NUREG-2124
Volume 1

Final Safety Evaluation Report

Related to the Combined
Licenses for Vogtle Electric
Generating Plant, Units 3
and 4

Docket Nos. 52-025 and
52-026

Figure 2.4-2. Basins Drainage Plan

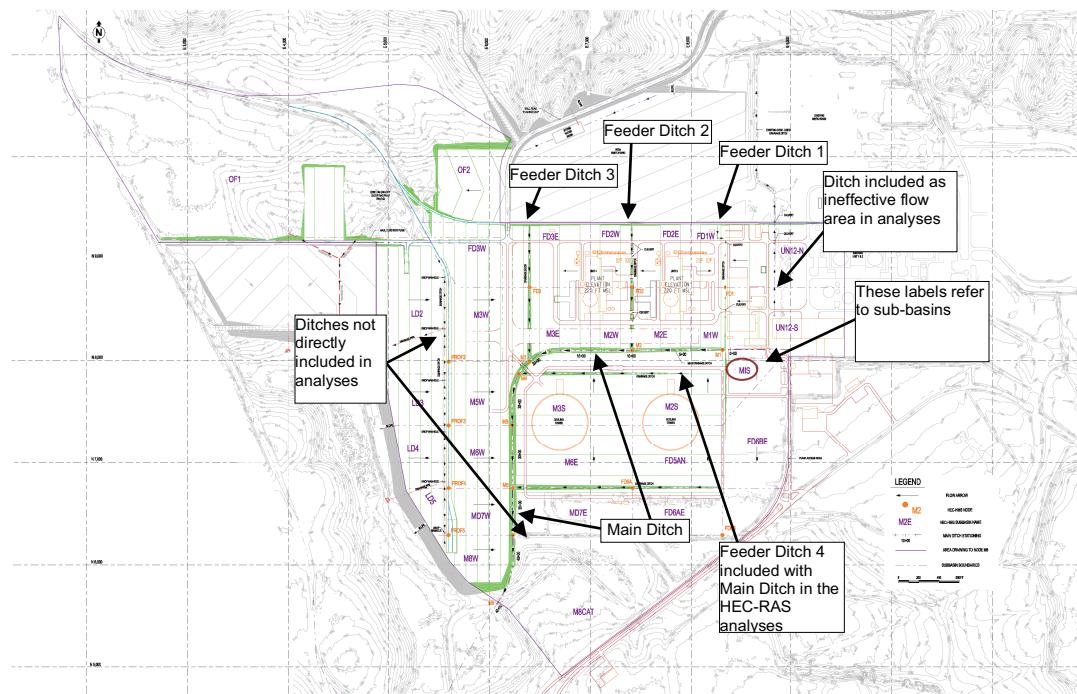
SER Figure 2.4-2 with the inventory of channels considered within the safety analysis and identified that two channels were not directly considered in the hydraulic (HEC-RAS) analysis by the applicant. A third channel was included with Feeder Ditch 1 as ineffective flow area. The applicant's analysis of the surface water flow used the HEC-RAS model to determine elevations of the surface water runoff from the site. An important aspect of the HEC-RAS model is that it uses cross sections to define the geometry of the overbank areas and ditch channels. A map with the locations of these cross sections was not originally provided in the VEGP COL FSAR. Therefore, the staff issued RAI 2.4.2-1 requesting the applicant provide a map with HEC-RAS cross-section locations. The applicant provided this in its response to RAI 2.4.2-1, and it can be seen in SER Figure 2.4-6 (corresponding to VEGP COL FSAR Figure 2.4-201a).

The staff's review of the HEC-RAS input files determined that a culvert within Feeder Ditch 3 is included in the model, but it is not included in VEGP COL FSAR Figure 2.4-102. RAI 2.4.2-1 requested the map be revised to identify all culverts and additional information on these features. SER Figure 2.4-2 also shows a surface feature that appears to cover Feeder Ditches 2 and 3 at their downstream ends, but no such feature appeared in the HEC-RAS input files. The staff also identified that the access road over Feeder Ditch 4 did not include a culvert, although it did include the Feeder Ditch 4 channel. The staff conducted a sensitivity analysis by blocking the channel and simulating the access road crossing as an inline weir (as with the other blocked culvert simulations completed by the applicant). This analysis produced only a small increase (0.01 ft) in water surface elevation in Feeder Ditches 1 and 2 and in the main ditch. The staff requested that the applicant's HEC-RAS model and results be updated by blocking the culvert in Feeder Ditch 4 and that these results be included with the FSAR. The applicant provided an updated HEC-RAS file under a supplemental response letter to RAI 2.4.2-1 dated August 5, 2009. The staff verified that Revision 2 of the VEGP COL FSAR adequately addressed the above discussion.

The applicant provided responses to the four items identified in RAI 2.4.2-1. Item 1 of the RAI requested clarification regarding channels presented in VEGP COL FSAR Figure 2.4-201 that were not included in the HEC-RAS hydraulic analysis of the localized probable maximum precipitation (PMP). The applicant stated in its response to the RAI that only the channels affecting flood levels in the power block are simulated in the HEC-RAS analyses. Other channels and drainage areas were included as contributors of flow from the local intense PMP (SER Figure 2.4-2). These channels are Feeder Ditch 5 and the ditch to the east of Feeder Ditch 1. The applicant's response included statements describing the process of including flows from these other sub-basins in the hydraulic analysis. SER Figure 2.4-3 (from the applicant-provided HEC-HMS files) shows the drainage area connectivity. Based on the applicant-provided HEC-HMS model, SER Table 2.4-2 shows the drainage areas that contribute to the flow in the ditches. The applicant also illustrated the connectivity of the drainage areas in SER Figure 2.4-2 by the identification of HEC-HMS nodes and sub-basins. The staff reviewed

Figure 2.4-4. HEC-RAS Water Surface Elevation Profiles for the Applicant's Model Setup

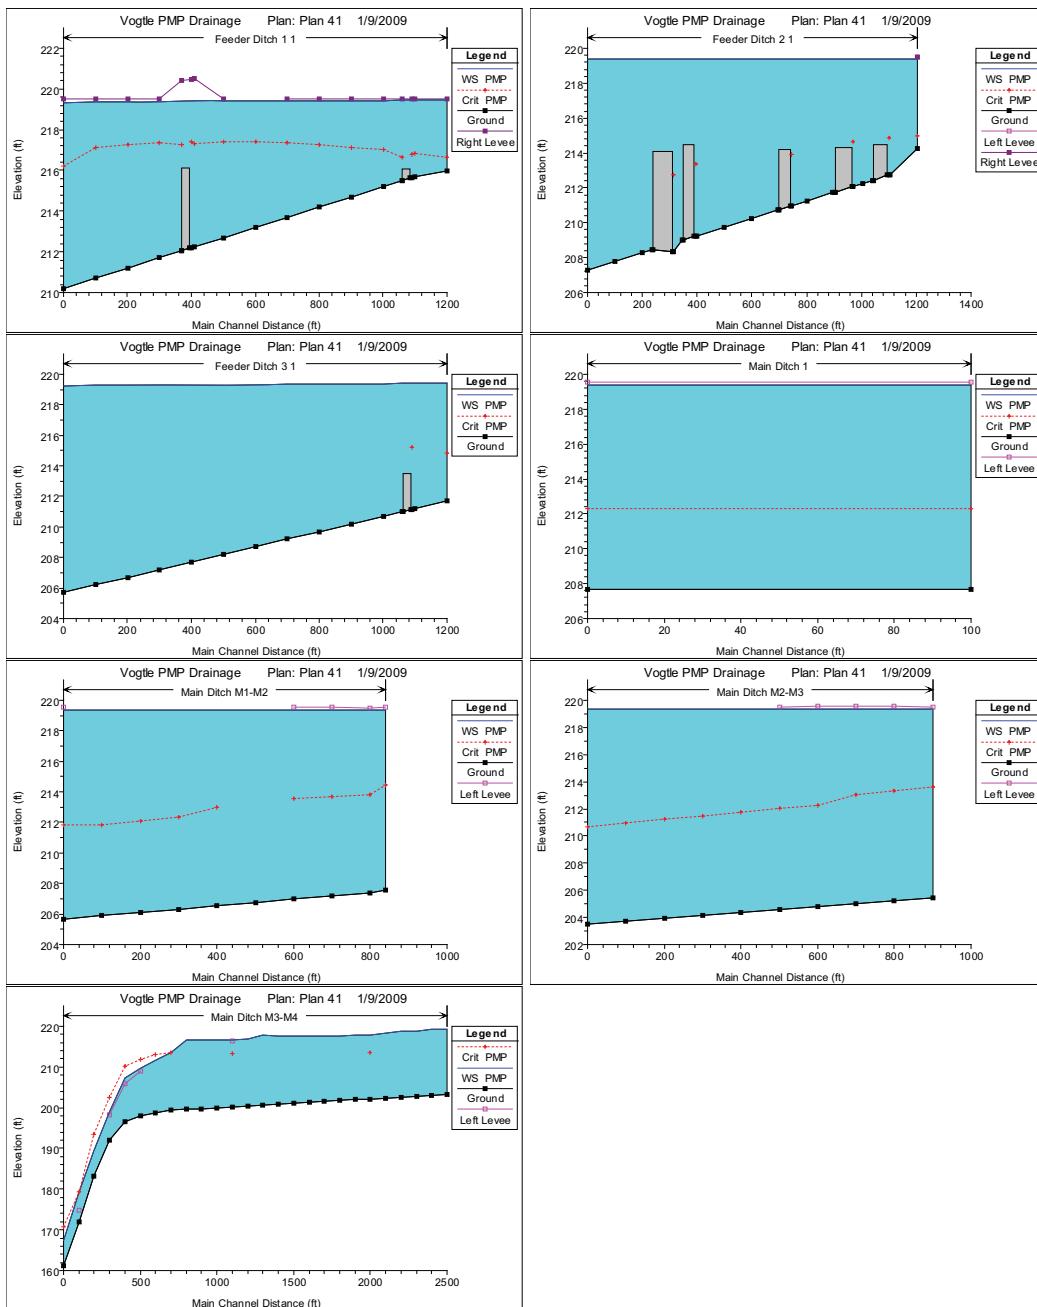
The applicant ran the HEC-RAS model under a mixed flow regime, indicating that both sub- and super-critical flows were expected to occur. As shown in SER Figure 2.4-4, extensive backwater conditions were produced in the feeder and main drainage ditches in the applicant's HEC-RAS model setup. At the downstream reach of the main drainage ditch, the water surface has a steep hydraulic gradient, and super-critical flows occur. Because this hydraulic feature occurs away from the safety-related structures, this super-critical flow occurrence is not relevant

The applicant states in VEGP COL FSAR Section 2.4.2.3 that the local PMP flood elevation produced by its HEC-RAS model is 219.45 ft MSL, which is 0.55 ft below plant elevation (220 ft MSL). This is the water surface elevation at the upstream end of Feeder Ditch 1. Water surface elevation profiles are shown in SER Figure 2.4-4.

Figure 2.4-5. Basins Drainage Plan with all Culverts and Heavy Haul Road Identified
(Based on VEGP FSAR Figure 2.4-201 and provided by the applicant in response to
RAI 01.04.02-1, Items 2 and 4)

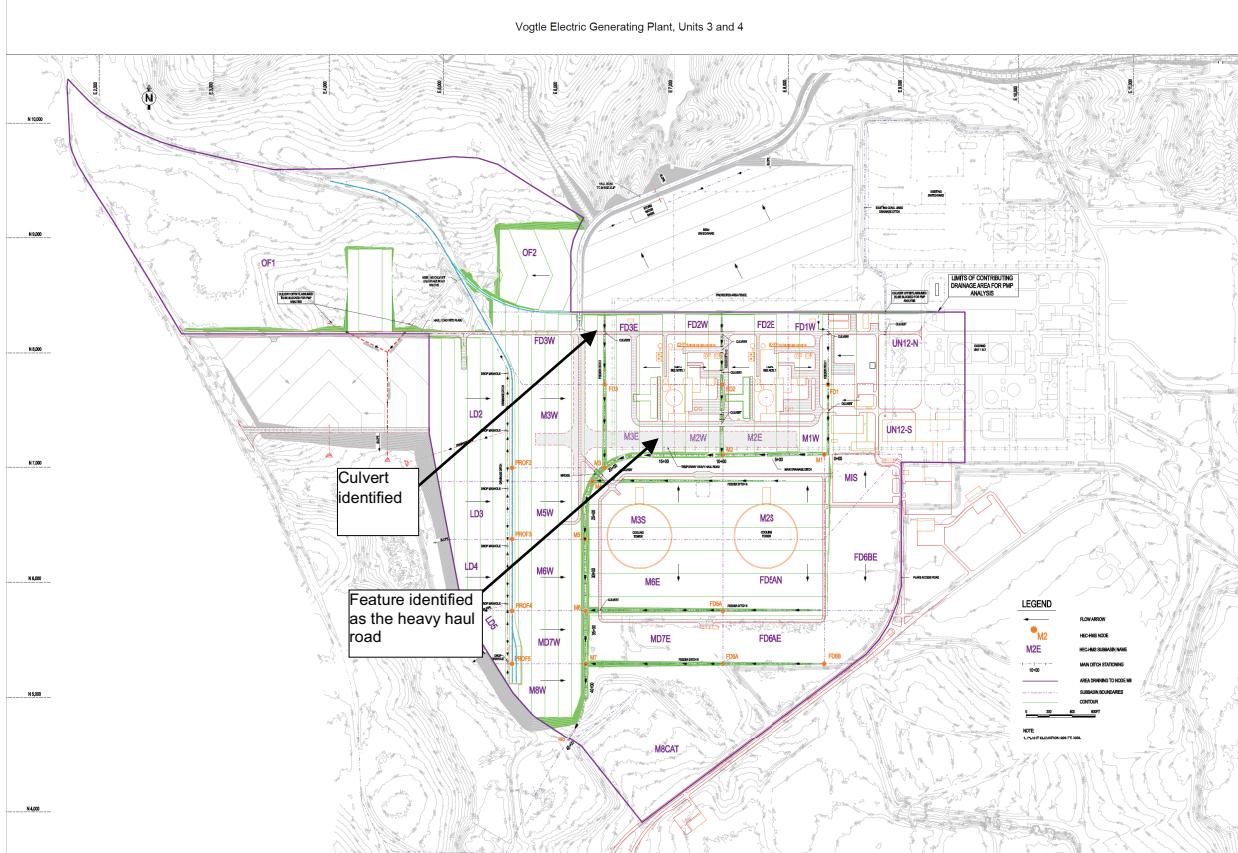
Item 2 of RAI 2.4.2-1 refers to a culvert included in the HEC-RAS model in Feeder Ditch 3 that is not included in VEGP COL FSAR Figure 2.4-201. Also, the fourth item of the RAI refers to an unknown feature shown in VEGP COL FSAR Figure 2.4-201. The applicant provided an updated figure in the response indicating the location of the culvert, SER Figure 2.4-5 (corresponding to VEGP COL FSAR Figure 2.4-201). The updated figure also identifies the unknown feature as a heavy haul road. The haul road would be used during construction and would have culverts placed in the drainage ditch to handle flows that occur during construction. The local PMP analysis was done for the operational condition in which the heavy haul road would have been removed. The applicant updated this figure in a letter dated March 27, 2009. The RAI response also included a discussion concerning the culvert at the downstream end of Feeder Ditch 4, in which the applicant states inclusion of the effect of a blocked culvert at this location would be minimal. Sensitivity analyses by staff confirmed this assertion as discussed previously. Therefore, Item 2 of RAI 2.4.2-1 is closed.

RAI 2.4.2-1, Item 4 requested clarification concerning a surface feature in Feeder Ditches 2 and 3. The applicant provided an updated figure in the response, which indicates the location of the culvert and which is shown in SER Figure 2.4-5 (corresponding to VEGP COL FSAR Figure 2.4-201). The applicant provided this information in a letter dated March 27, 2009. The staff verified the updates to the FSAR for the inclusion of the updated Figure 2.4-201; therefore, RAI 2.4.2-1, Item 4 is considered closed.

Figure 2.4-6. Basins Drainage Plan with Cross Section Locations Used in the HEC-RAS Analyses

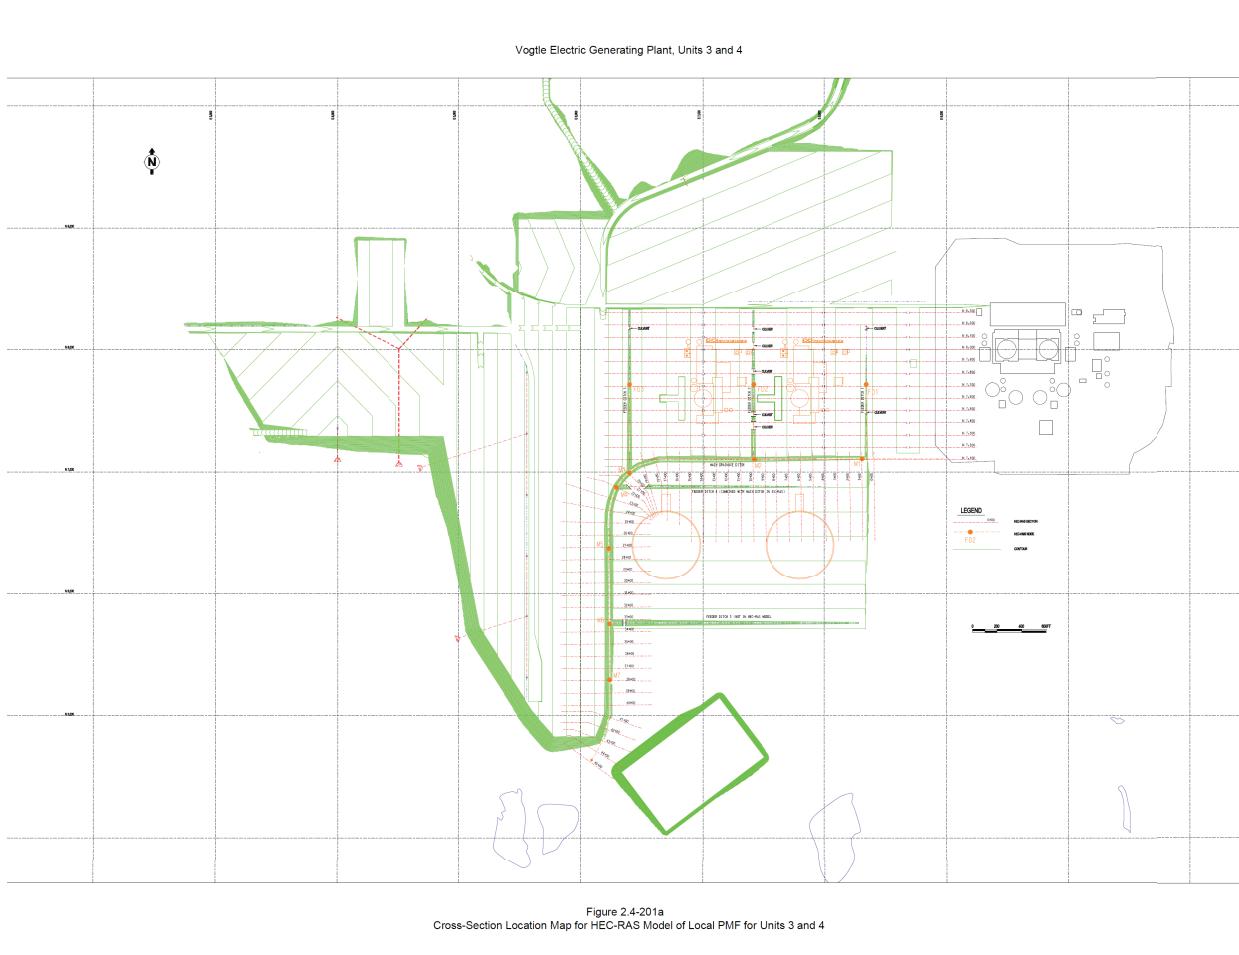
RAI 2.4.2-1, Item 3 asked for a figure that includes the locations of the cross sections used in the HEC-RAS analyses. The applicant provided a figure in the response, SER Figure 2.4-6 (corresponding to VEGP COL FSAR Figure 2.4-201a). The applicant also provided proposed

text for the revised FSAR to include the figure under letter dated March 27, 2009. The staff verified the updates to the VEGP COL FSAR, Revision 2 for inclusion of the updated Figure 2.4-201a; therefore, RAI 2.4.2-1, Item 3 is considered closed.

Figure 2.4-7. Basins Drainage Plan with Cross Section Locations Used in the HEC-RAS Analyses

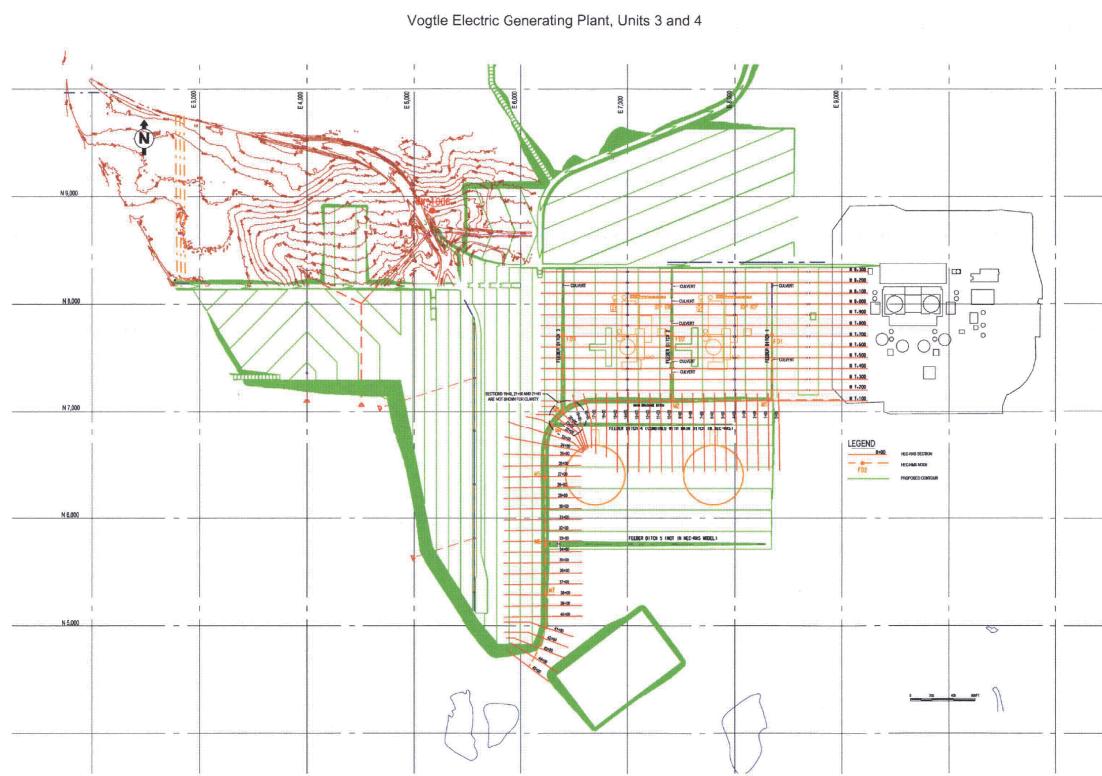
- Updates to the maximum probable maximum flood (PMF) elevation discussion for the local intense precipitation event.
- Assumptions made in the hydraulic analysis concerning surface material type, conservative analysis of culverts with complete blockage, and use of steady-state flows, which is conservative.
- Updates to the discussion concerning flow regime (sub- and super-critical) locations in the main stem ditch.
- Updates to VEGP COL FSAR Table 2.4-207 summarizing the revised HEC-RAS hydraulic model output.
- Updates of proposed VEGP COL FSAR Figure 2.4-201a reflecting the inclusion of the blocked culvert at the downstream end of Feeder Ditch 4 (SER Figure 2.4-7).
